# Access Compliance Report

## Public Rights-of-Way

### (Curb Ramps)

Intersection ID: 43737	Main Street: ASHLYN_CHASE_CT	Cross Street: BRIDGEVIEW_LN	Location:	N
ADA ID: 59F862E5176F	Ramp Type: BlendTrans1	Initial Pass/Fail: Fail	Overall Compliance: No	Severity Score: 1.25
Codes/Mitigation Info/Possible Solution		Field Measurements/Component Compliance

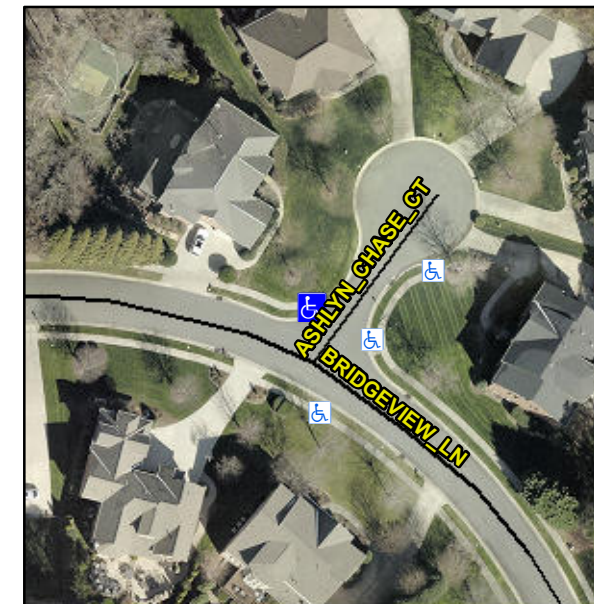
**GTR GAP 2.5, LNDG GAP 1.5**

**Not Found, R304.5.3**

**Remove & Replace Curb Ramp With Two New Directional Ramps or Equivalent.**
